Amendments to the Specification

[0014] The drag reducing additives of this invention have the basic chemical structures of the maleated fatty acid drag reducers given below:

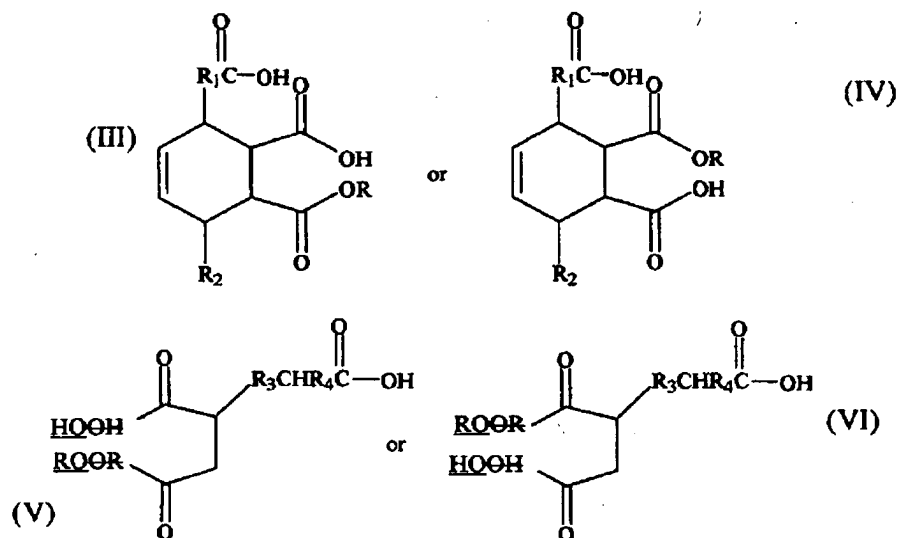
In paragraph [0014] on pages 4-5, please correct structures (V) and (VI) as shown:

where R is an organic moiety including alkyl, aryl, aralkyl, alkaryl or amine groups;

R_1 is a generally linear organic moiety of from about 2 to about 20 carbon atoms;

R_2 is hydrogen or a generally linear organic moiety of up to about 20 carbon atoms,

where the total number of carbon atoms in R_1 and R_2 are from about 10 to about 20 carbon atoms;

R_3 is an alkylene or alkenylene group of from about 2 to about 15 carbons; and

R_4 is an alkylene or alkenylene group of from about 2 to about 15 carbons;

and inorganic, organic, and amine salts thereof. By "alkenylene" is meant a hydrocarbon moiety bonded on either end to the shown structures (similar to alkylene) but which is unsaturated with at least one C=C double bond.
